INDIANA DEPARTMENT OF TRANSPORTATION

AGENDA

January 18, 2024, Standards Committee Meeting

RE: Agenda for the January 18, 2024, Standards Committee Meeting

REVISION TO SPECIAL PROVISIONS AND STANDARD DRAWINGS
 E 801-TPAR-11 TEMPORARY CURB RAMPS (proposed new)

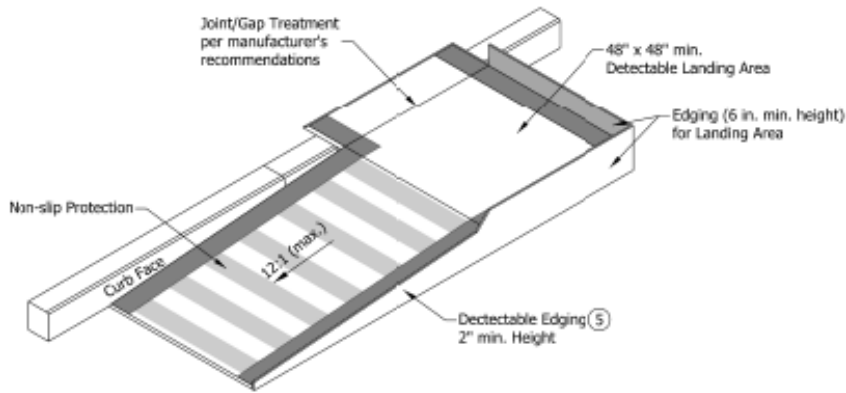
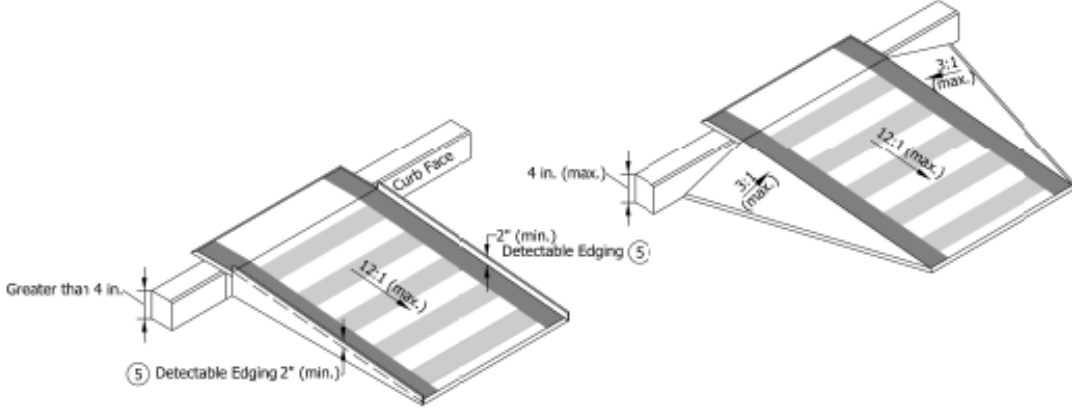
6. The rise of a single temporary curb ramp shall be no more than 30 in. If more than one temporary curb ramp is needed at a location due to the change in elevation, a minimum 5 ft landing area shall be used between curb ramps. The landing area shall have a slope of less than 2.00%.

E 619-PRWS-02 COATING REQUIREMENTS FOR WEATHERING STEEL (proposed draft)

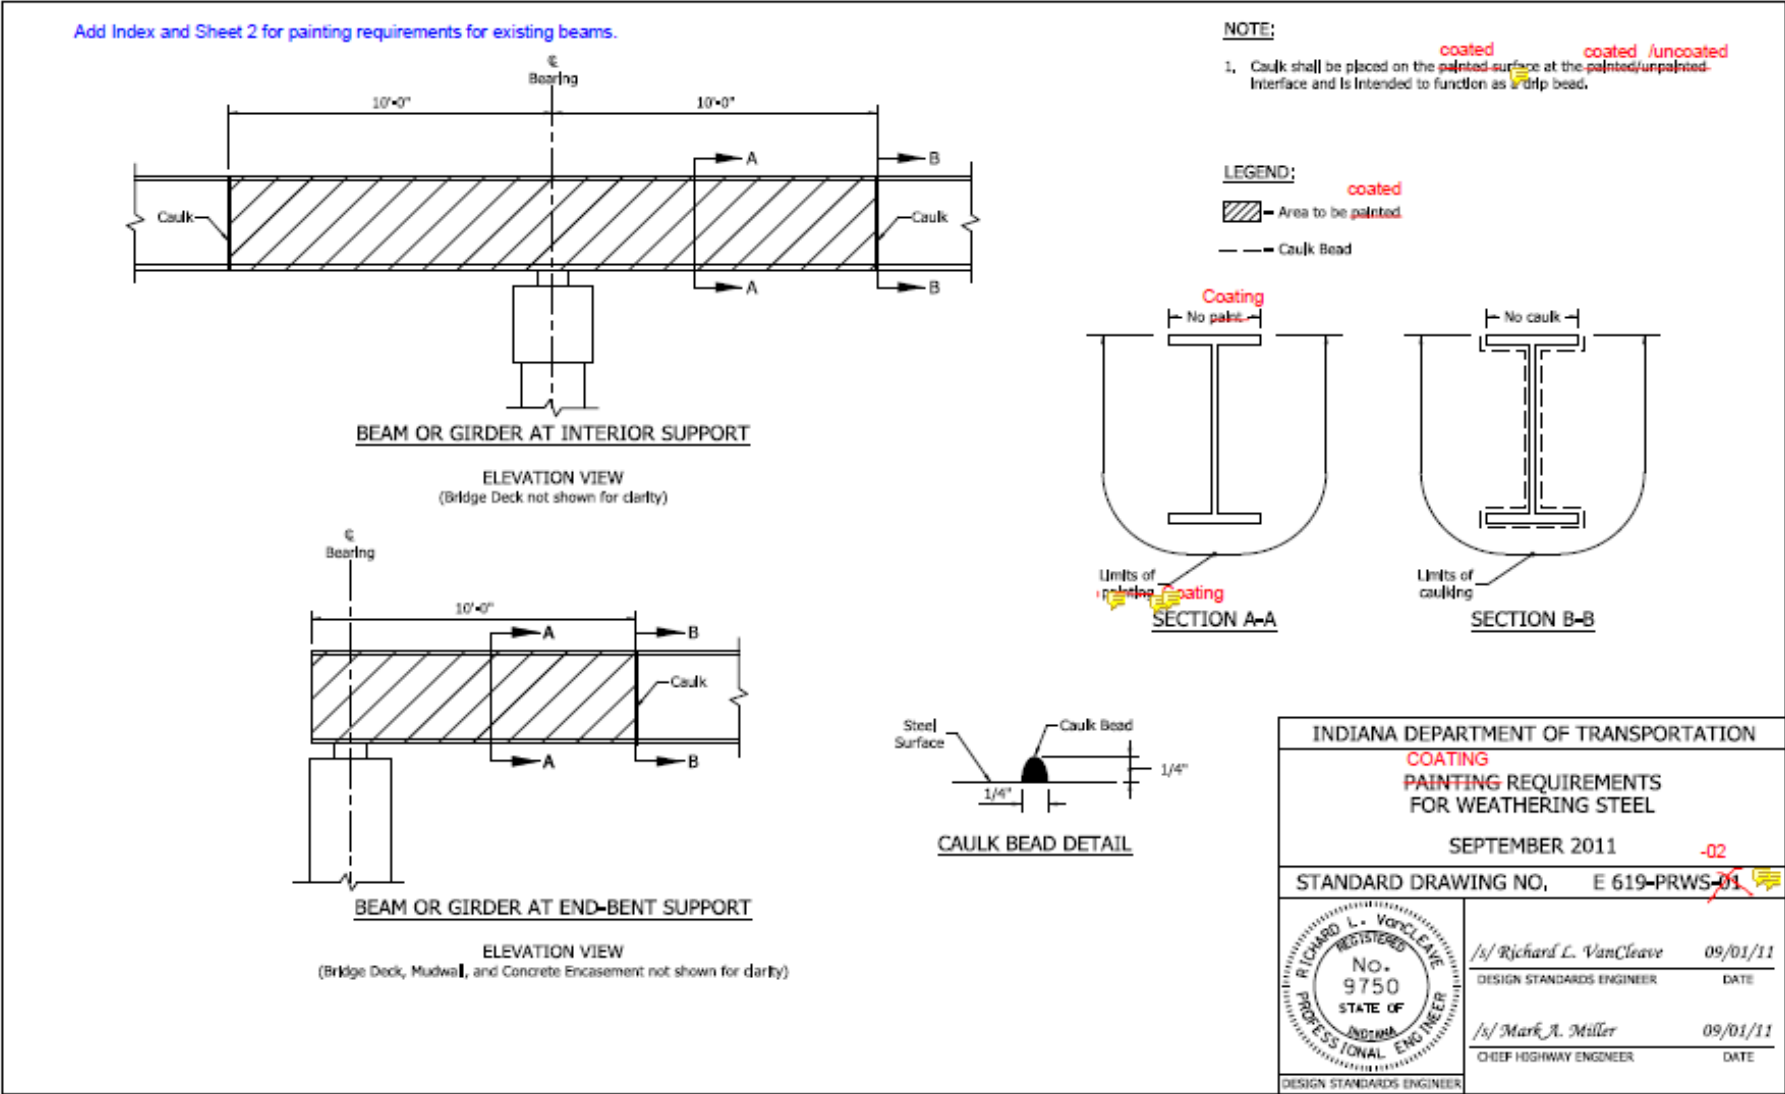
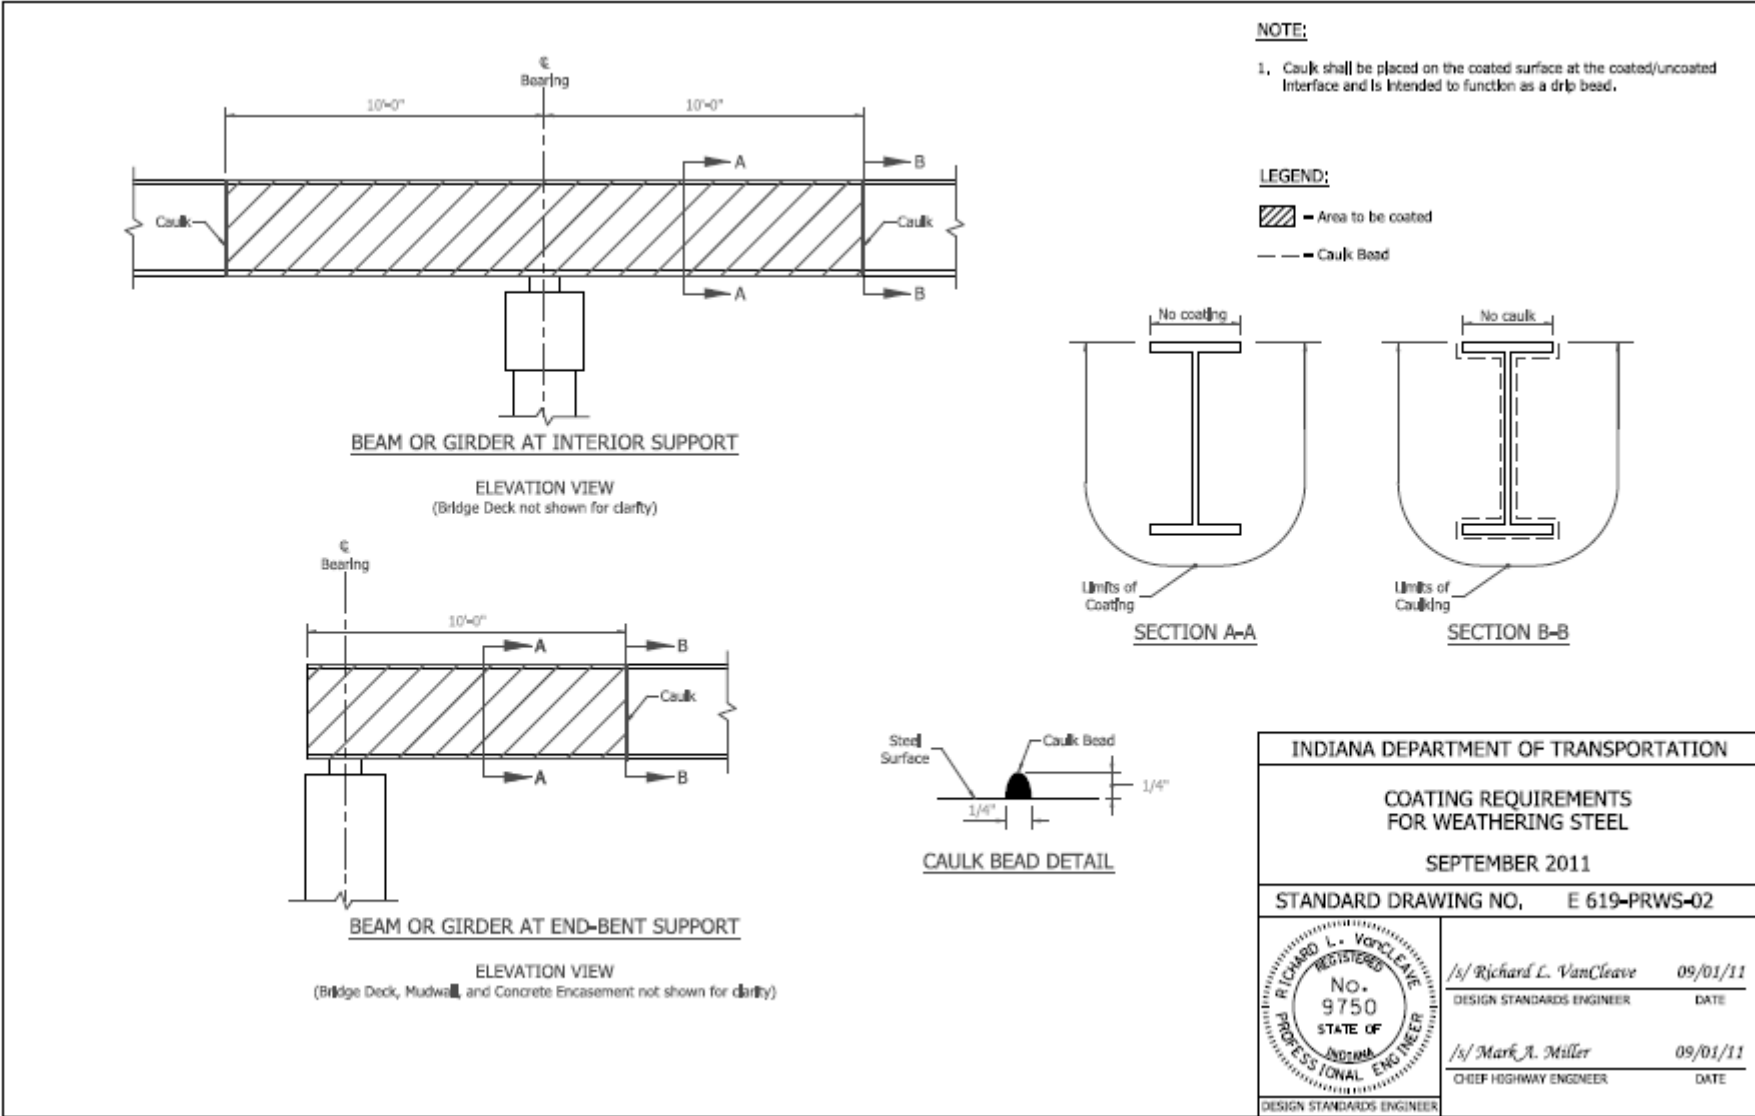
PROBLEM(S) ENCOUNTERED: Standard Drawing needed to illustrate partial coating (painting) limits for existing steel beams as part of semi-integral end bent conversion. Revisions to *Standard Specifications* 619 were approved February 2023. A sketch was agreed upon, but Standard Drawing was not created. Designers are currently showing limits on the construction plans.

PROPOSED SOLUTION: Add details to Standard Drawings series 619-PRWS

Is this item editorial? Terminology revisions (painting to coating) on existing 619-PRWS-01 are considered editorial.

801-T-XXX PROTECT THE QUEUE TRUCKS (proposed new)

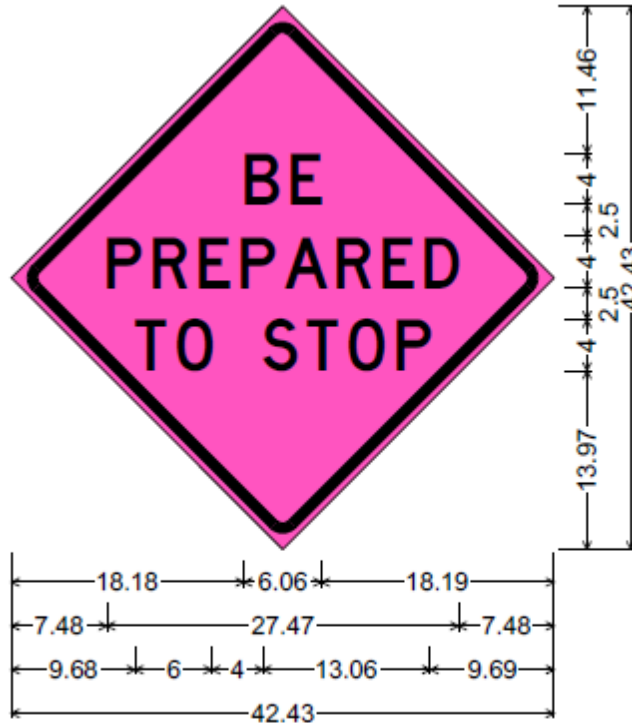
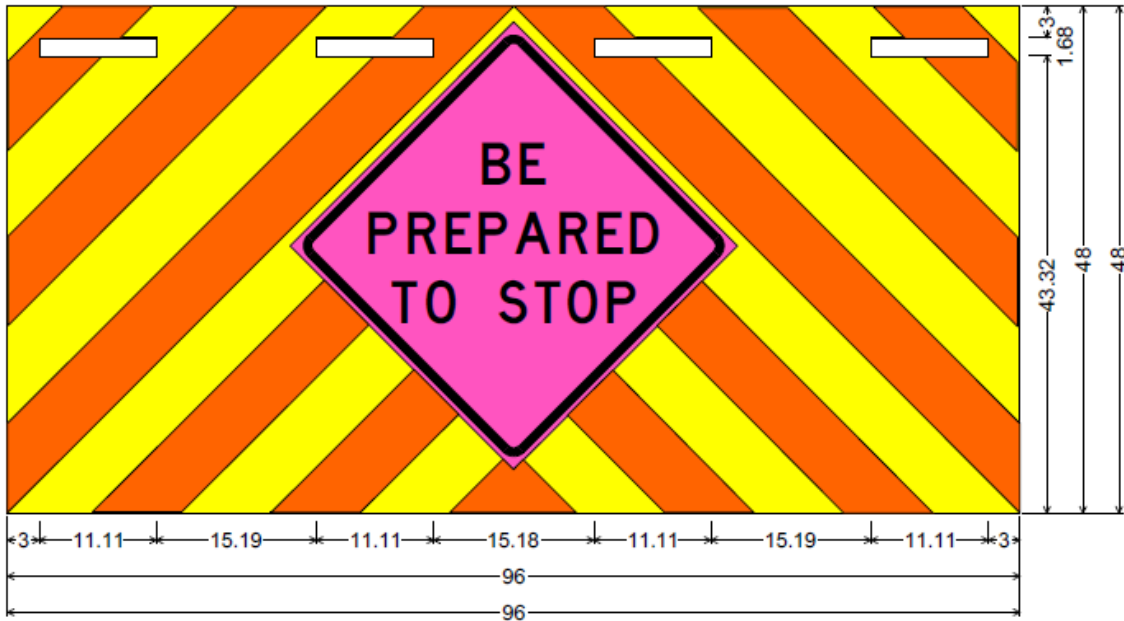
In accordance with the PTQ Truck Detail, all PTQ trucks shall include queue warning features consisting of the following equipment:

Alternating red and yellow stripes, 6 in. wide, 3M™ Diamond Grade™ Emergency Vehicle Markings 983-71NL and 983-72NL or equivalent. The stripes shall be installed in an upside down "V" fashion in accordance with emergency vehicle marking schemes, as shown on the PTQ Truck Detail. To ensure a robust color, printed sign material shall not be used.

Four, Whelen Strip-Lite Plus Series SmartLED® WARNING DUO Model: PSD02FCR 12V RED/WHT flasher lights, or equivalent, shall be installed in accordance with the PTQ Truck Detail.
